# Comments to Florida Department of Transportation Pavement Type Selection Process

Jim Mack, PE, CEMEX

## Policy Issues related to Concrete Pavement Design

**Figure 1: Cost Example on looking at the benefits of a Drainage Layer**

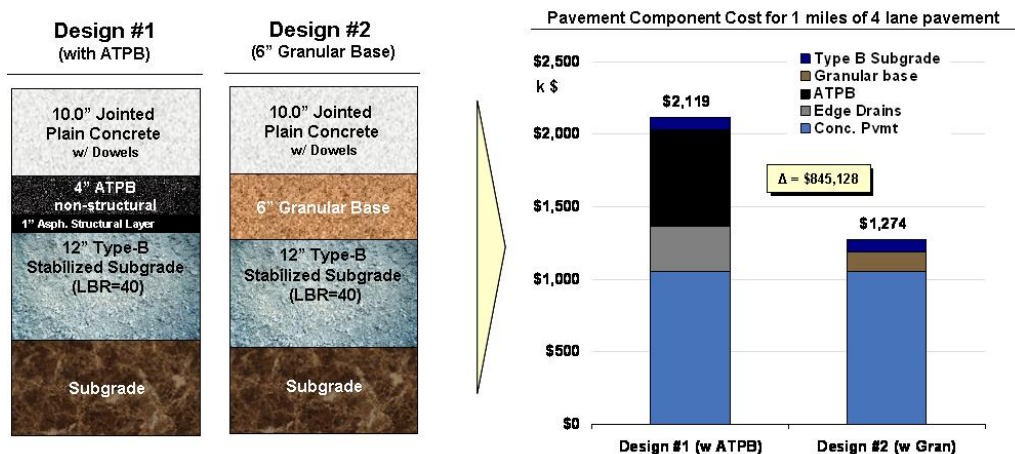
As such, we do not believe that FDOT should use a PATB unless there are overriding circumstances as to why it should be used over standard stabilized or granular base. Furthermore, when it is used, its use should be justified on a cost/benefit analysis that shows the drainage layer extends the life long enough to cover its NPV. Figures 1 and 2 show an example of this for a medium volume road (8.5 million ESALS). In Figure 1, Design 1 is a typical FDOT design using the ATPB and drainage system. Design 2 is alternate design using only a 6” granular base. The difference in initial costs is \$845,128. For the drainage layer to be effective, it must extend the pavements life to overcome this differential.

A drainage system should not be required for all concrete pavements, and when it is used, it should be based on the specific site conditions and justified using a cost / benefit analysis.

**Figure 2: Life Cycle Costs Comparison to determine if a Drainage Layer is a Cost Effective Expenditure**

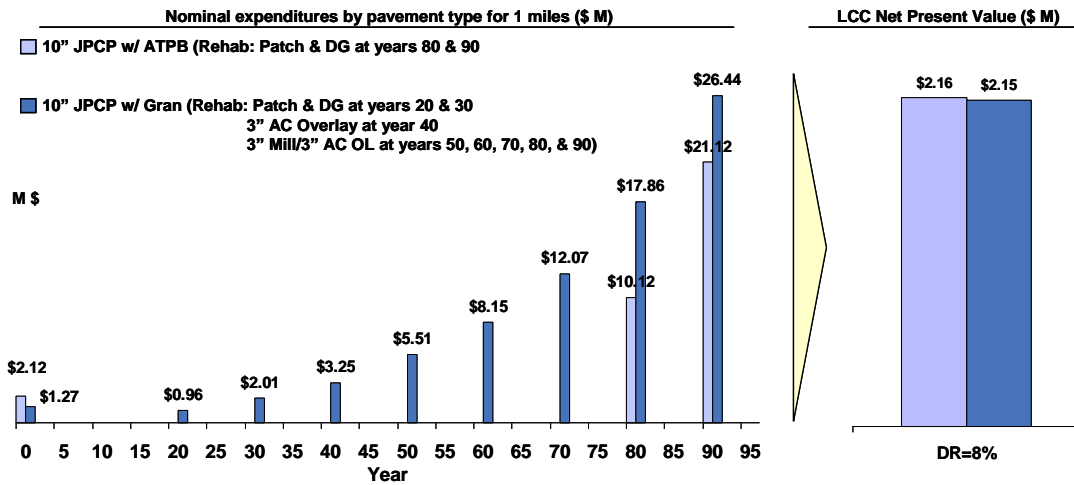
Figure 2 is the life cycle cost analysis for these pavements assuming that Design 2 last 20 years. Based in this analysis, Design 1 with the APTB needs to last an additional 60 years (eg 80 years before first rehabilitation) for the expenditure for the ATPB to be worth the costs. Note that while there may be some argument that Design 2 is a 20 year design, it is difficult to argue, at least in this example, that the use of the PATB is cost effective.
